Charles Church

Response to Highways comments dated 30th May 2025

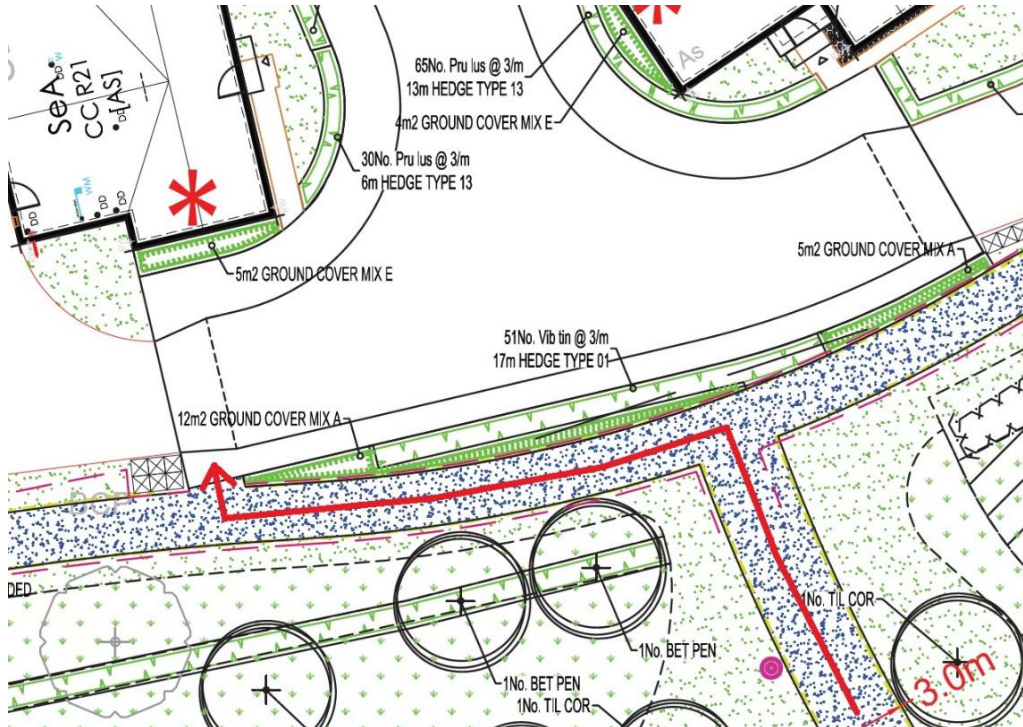
- Drawing POS & Existing Footpaths Surface Scheme - Rev C addresses the physical construction issues of drainage, surfacing specification and widths. The confirmation of a three-metre surface for Bridleway U67 is welcomed. However, the plans do not clarify how the north end of the bridleway will connect with the end of the adjoining cul-de-sac to ensure a smooth transition particularly for cyclists using both these routes. Of specific concern the submitted drawing Detailed Soft Landscape Proposals - JBA 23-348 -04 Rev M appears to show a hedge blocking movement between the two routes at this point, which would be an unlawful obstruction. [See image below \(Sketchley Landscaping Bridleway\) which demonstrates with a red line/arrow annotated on the approved landscaping plans the route and how this is shown to connect into the turning head.](#)
